Harrisville City Planning Commission

Wednesday, July 13, 2022 – 7:00 p.m.

RE: **DIXON CREEK PARK PHASES 1-5 SUBDIVISION**
Preliminary Plat Submittal

Date: July 7, 2022

C400
SITE PLAN

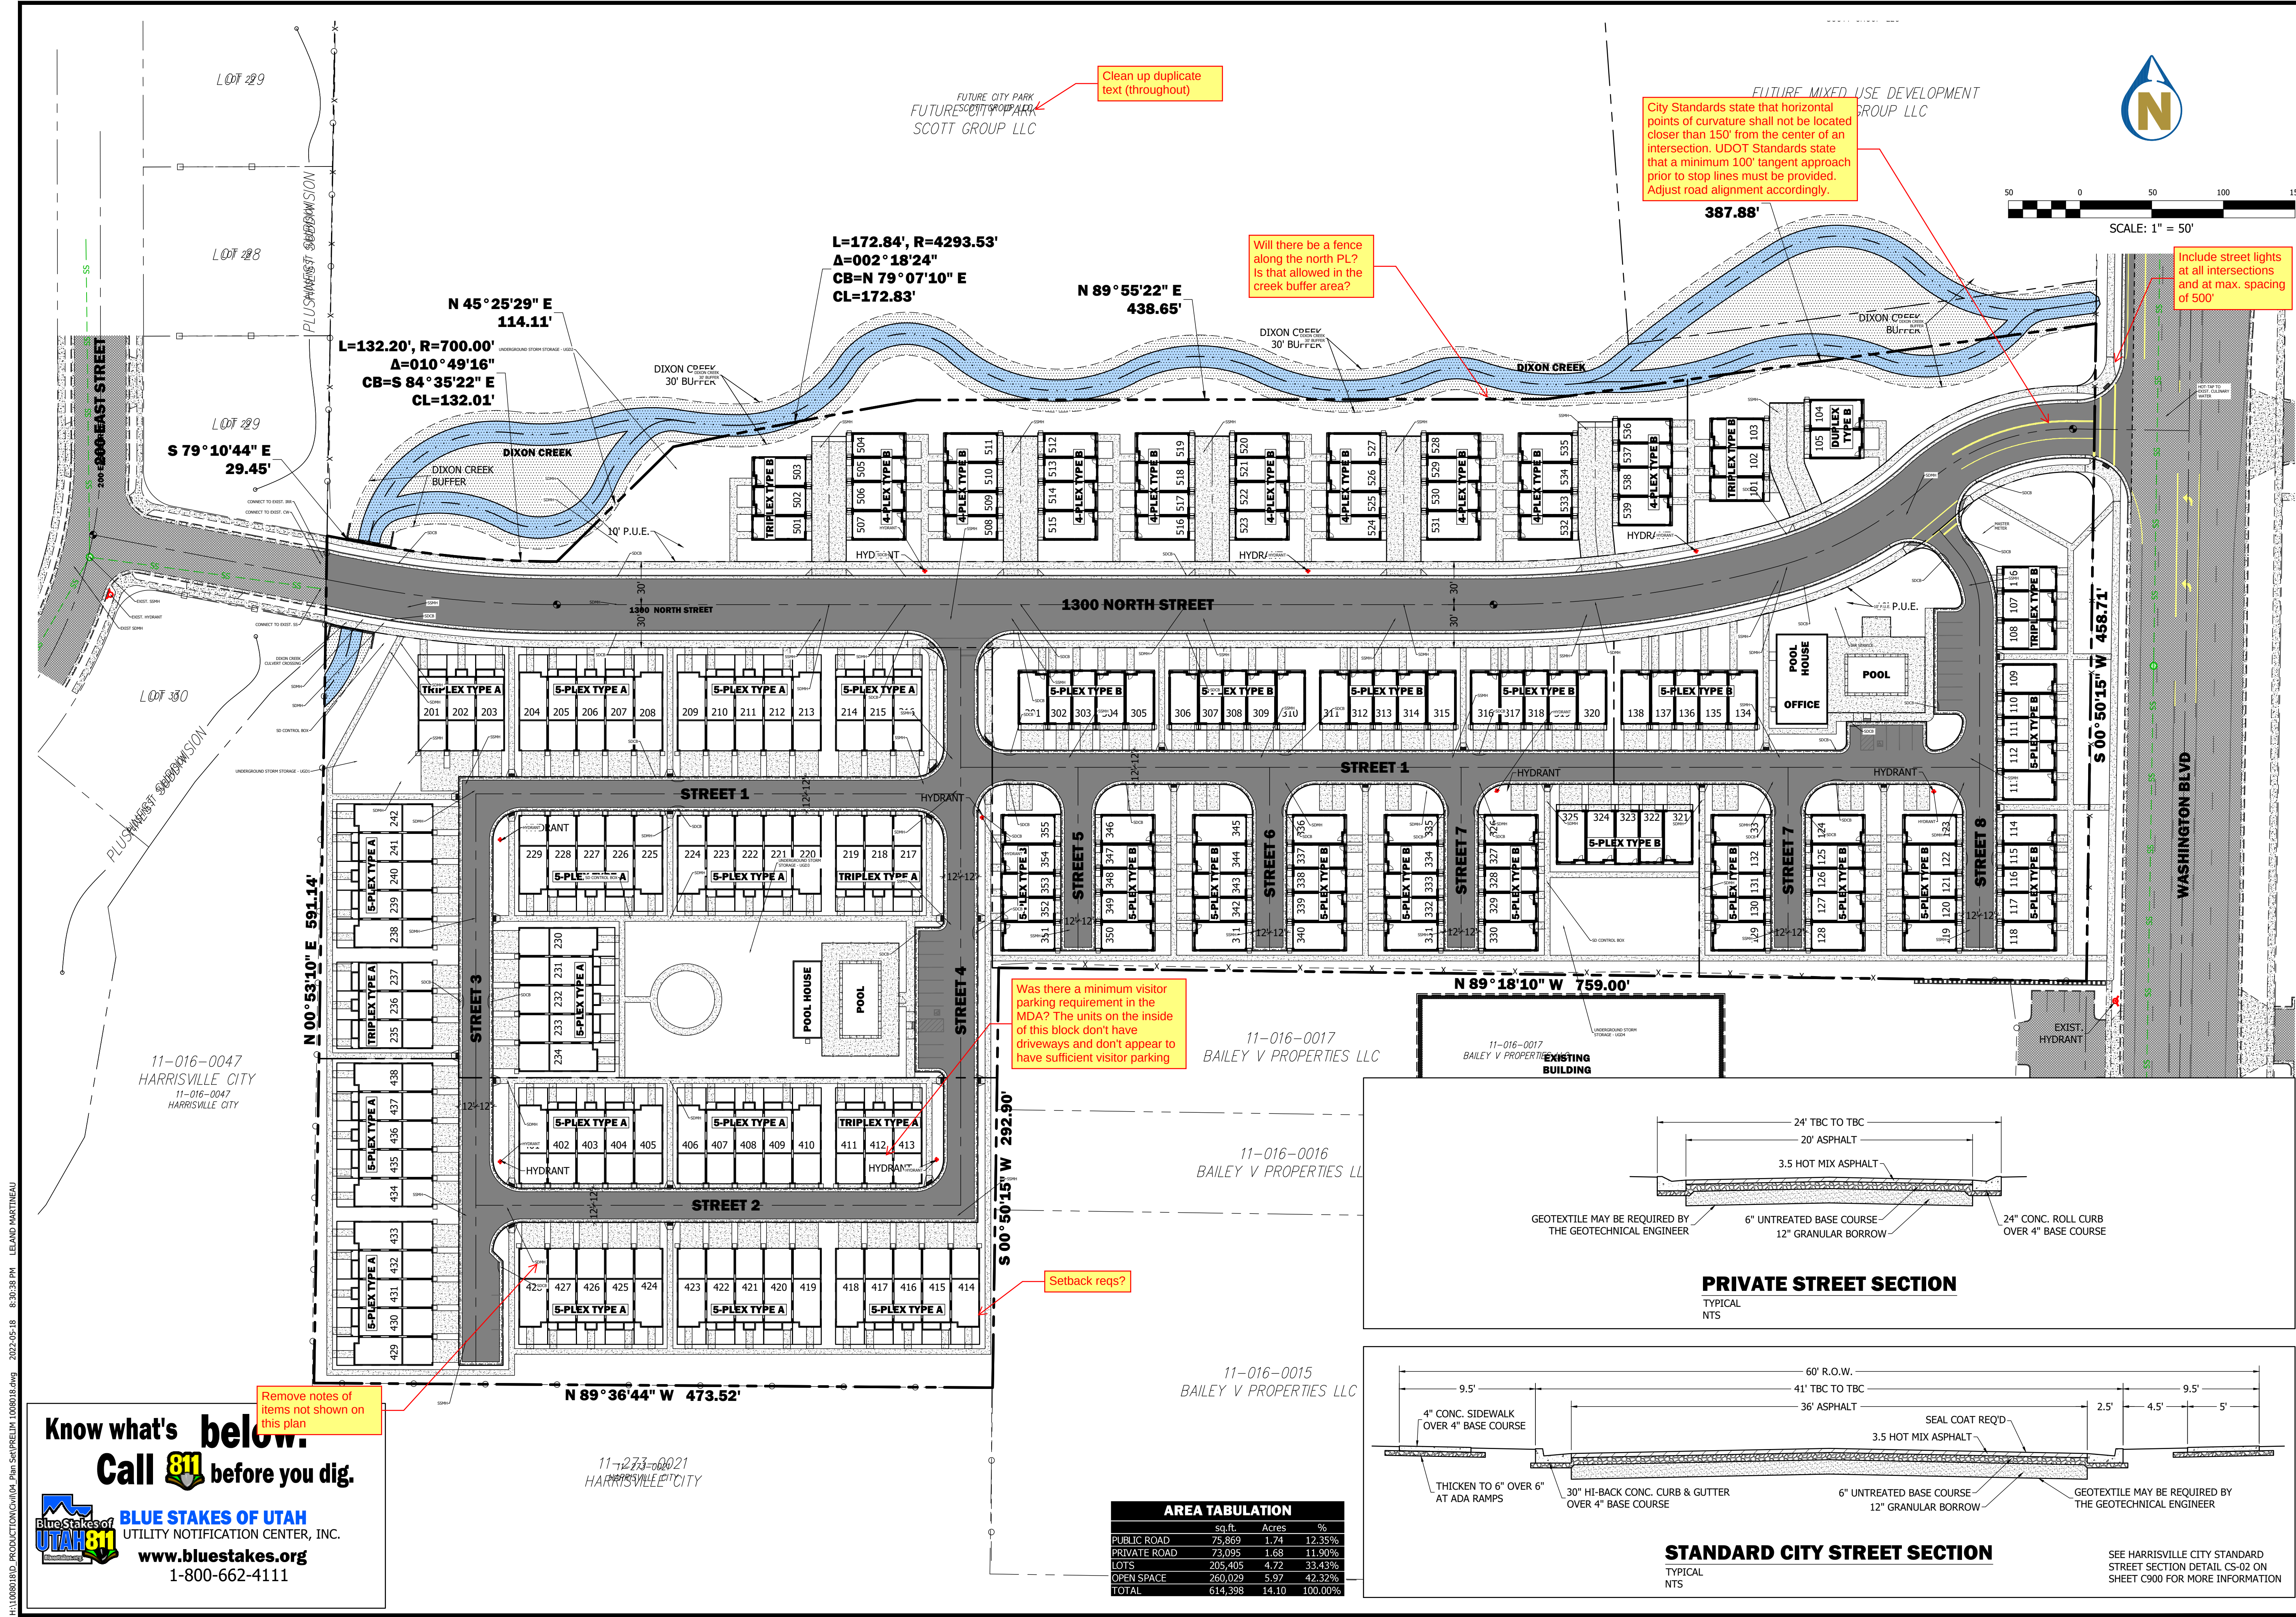
Clean up duplicate text (throughout)

City Standards state that horizontal points of curvature shall not be located closer than 150' from the center of an intersection. UDOT Standards state that a minimum 100' tangent approach prior to stop lines must be provided. Adjust road alignment accordingly.

Will there be a fence along the north PL? Is that allowed in the creek buffer area?

Include street lights at all intersections and at max. spacing of 500'

Was there a minimum visitor parking requirement in the MDA? The units on the inside of this block don't have driveways and don't appear to have sufficient visitor parking

Setback reqs?

Remove notes of items not shown on this plan

C410
PRELIMINARY PLAT - PHASE 1

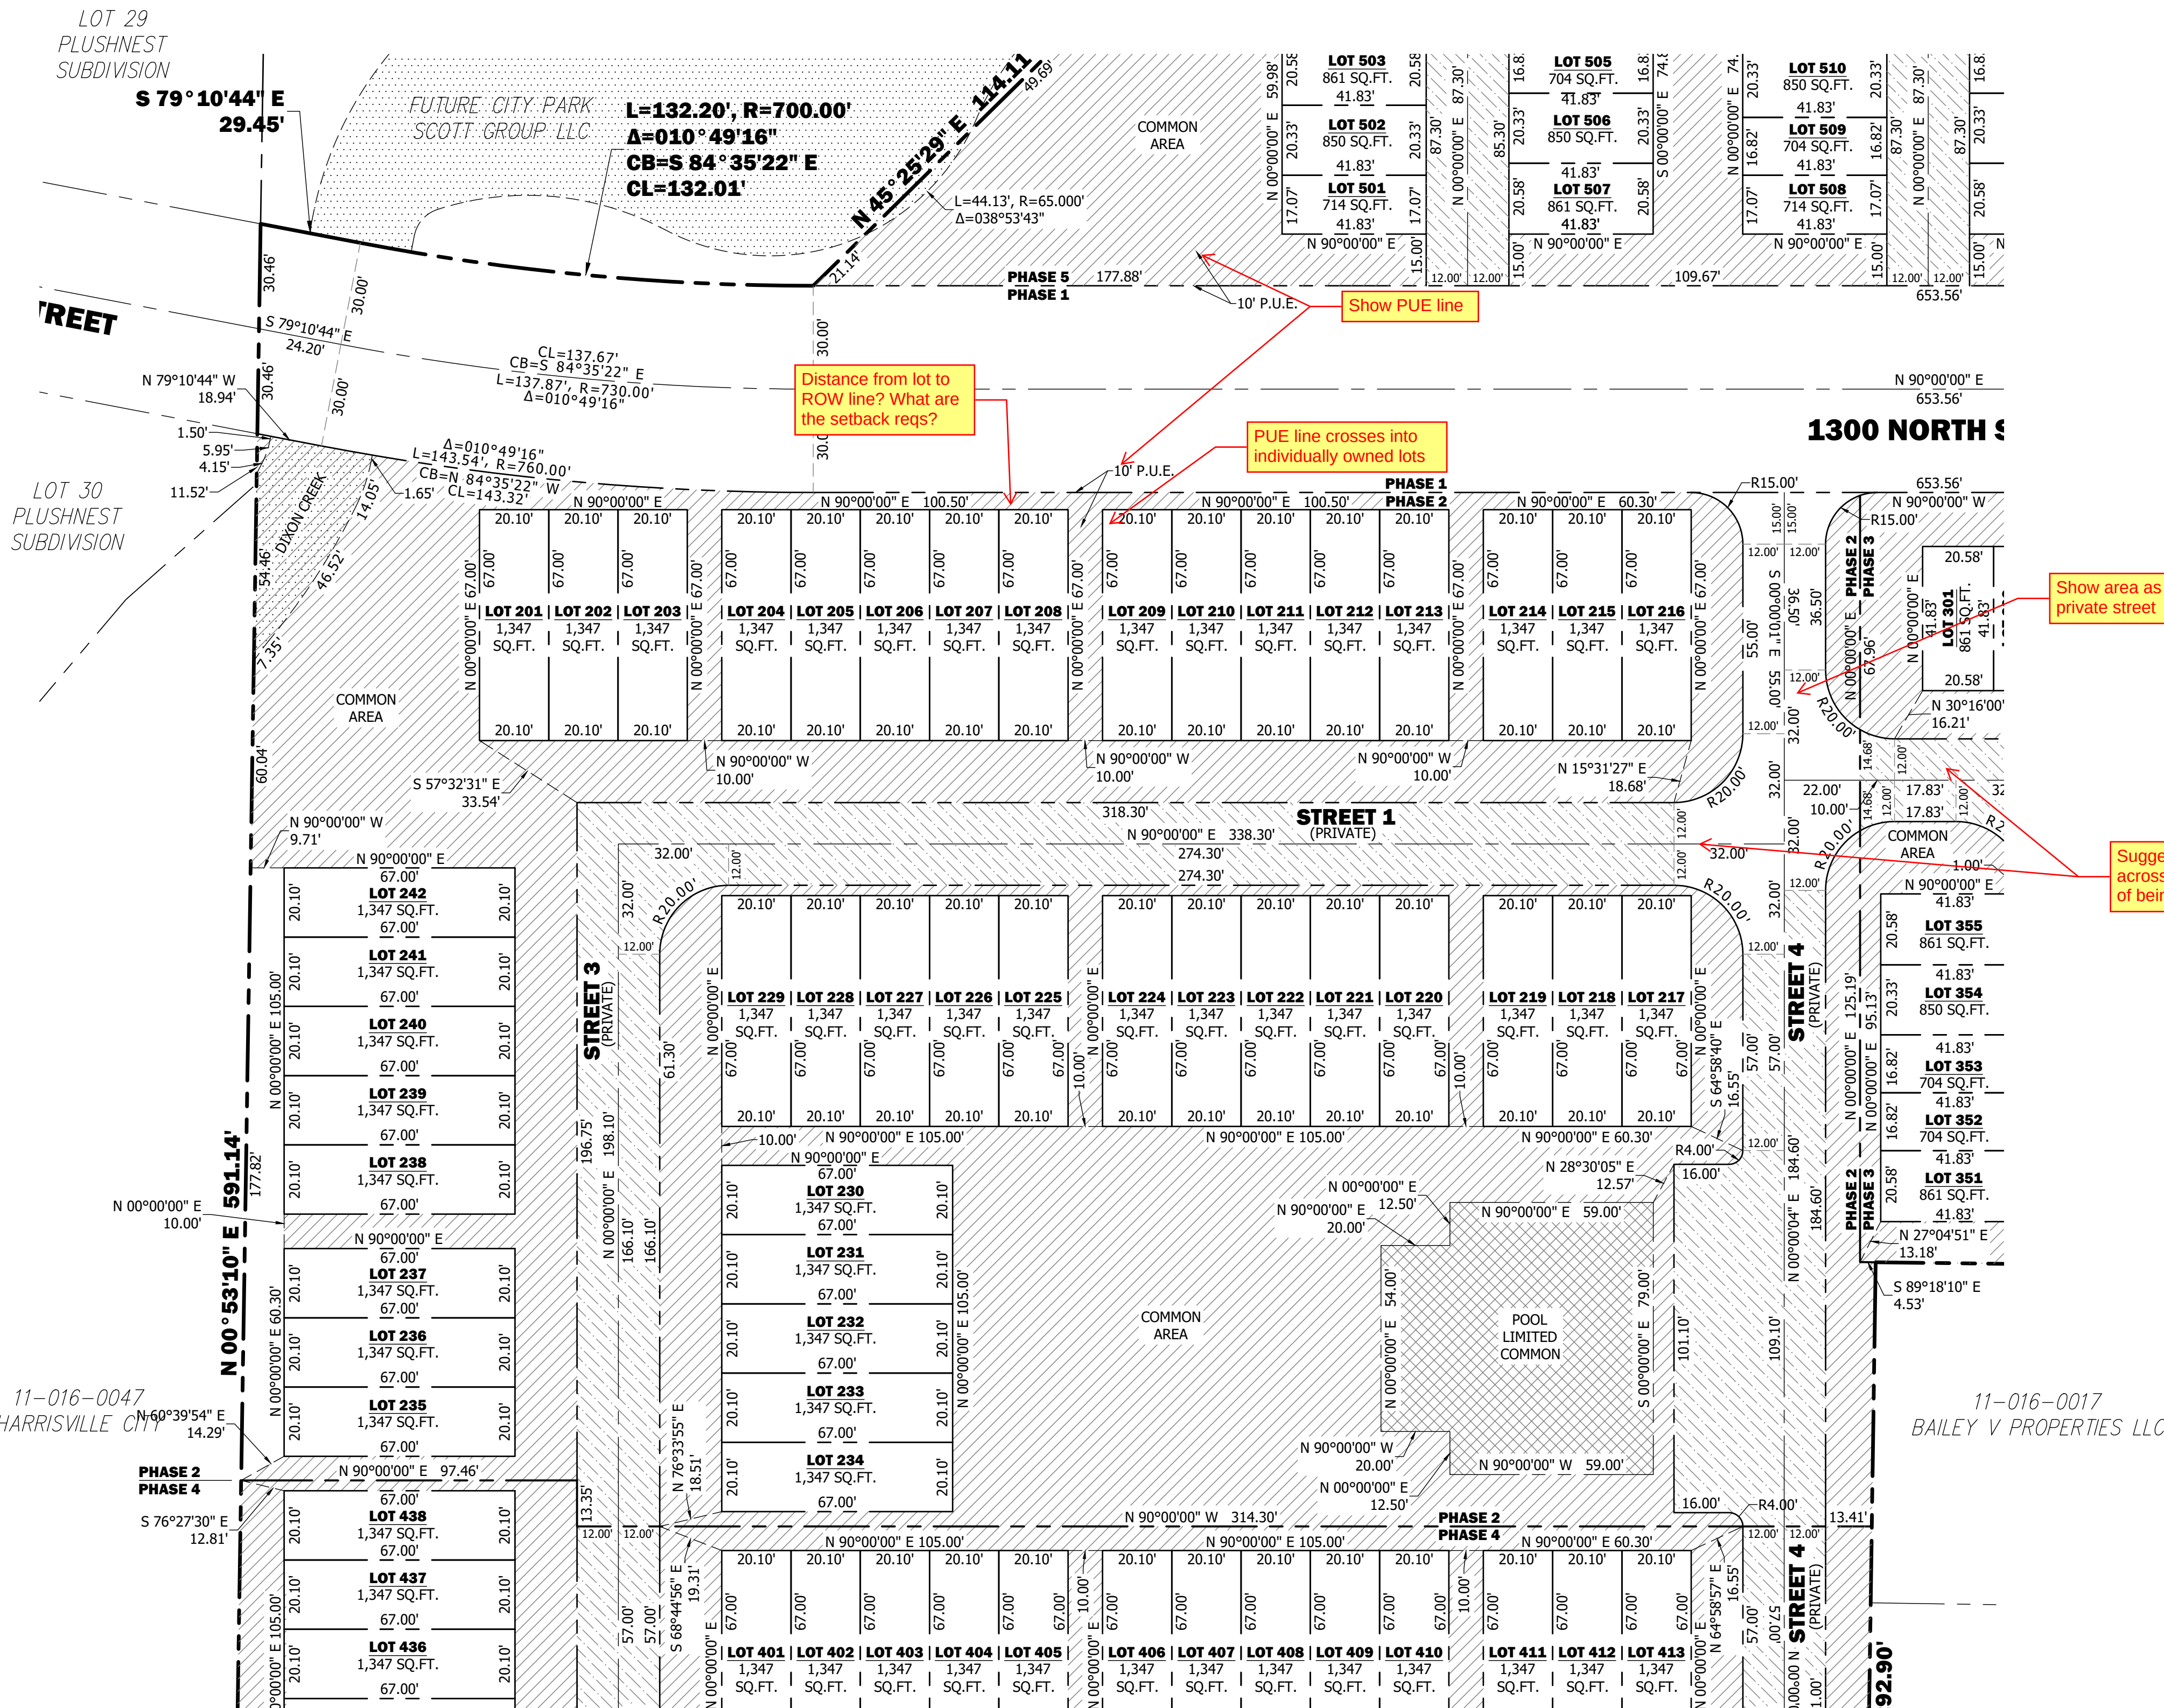
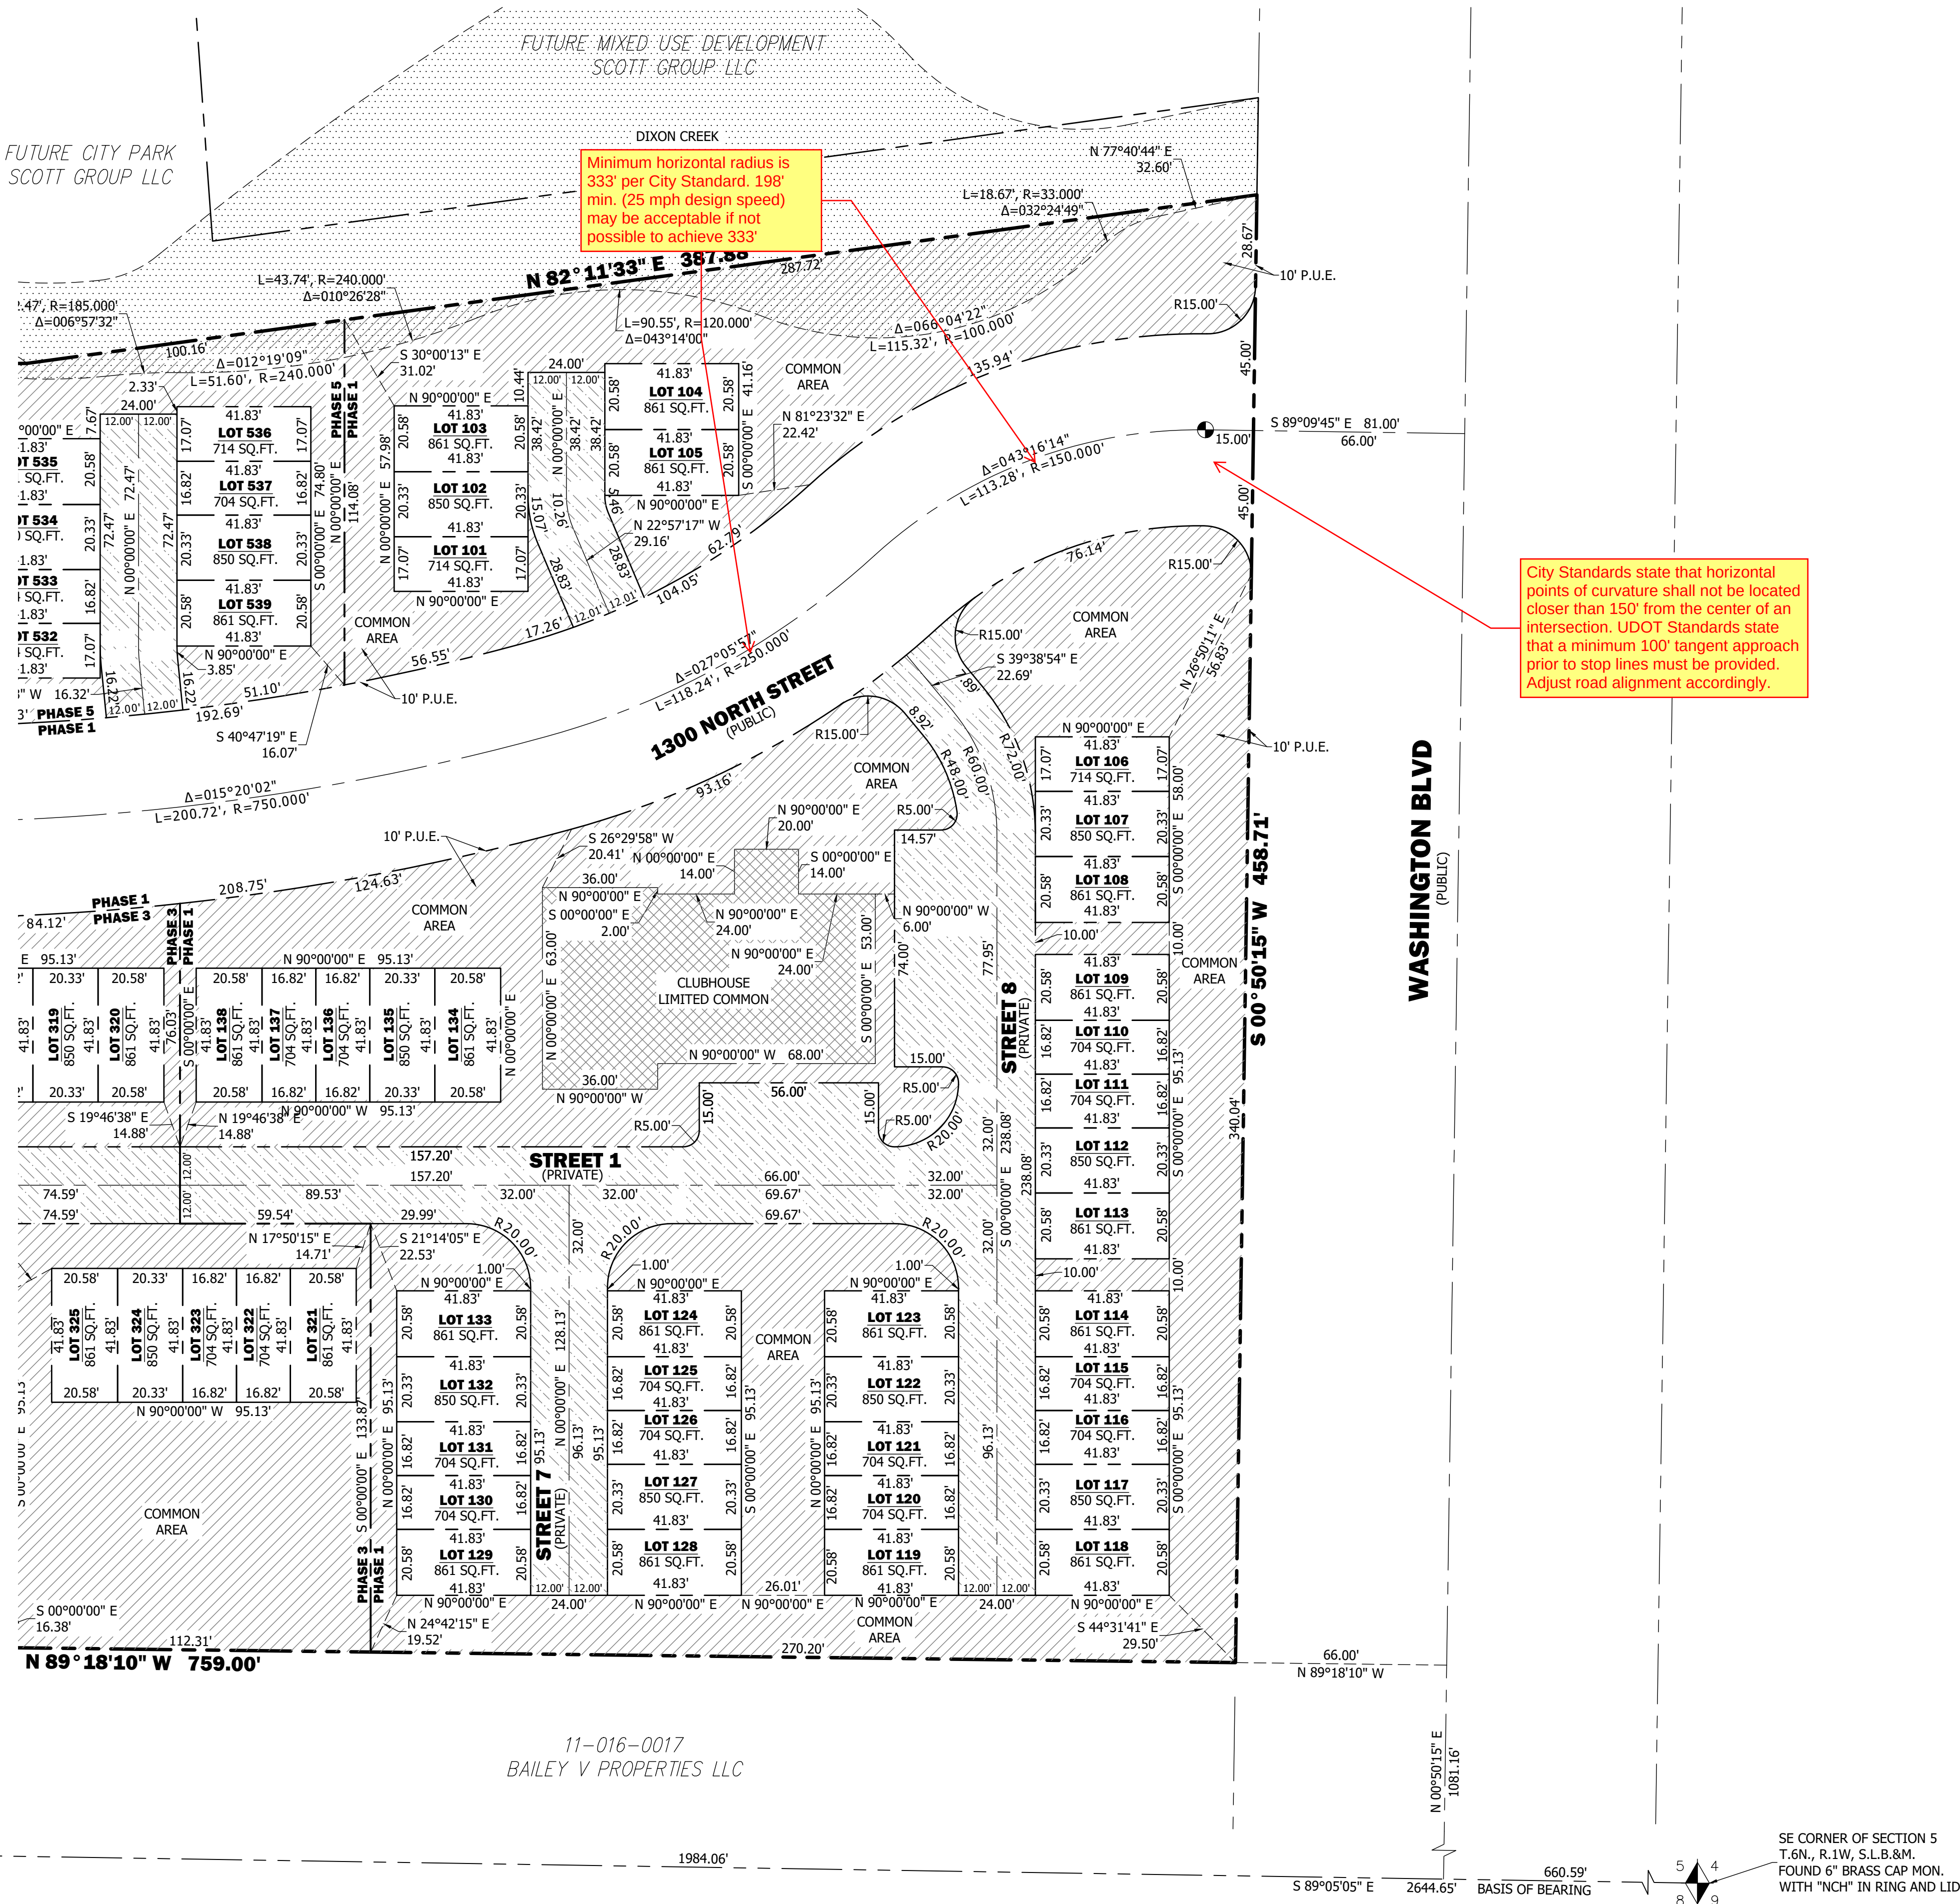
Plat to be reviewed and approved by the Weber County Surveyor's office. Add signature blocks, narrative, description, owner's dedication, notes, etc. on the final plat

City Standards state that horizontal points of curvature shall not be located closer than 150' from the center of an intersection. UDOT Standards state that a minimum 100' tangent approach prior to stop lines must be provided. Adjust road alignment accordingly.
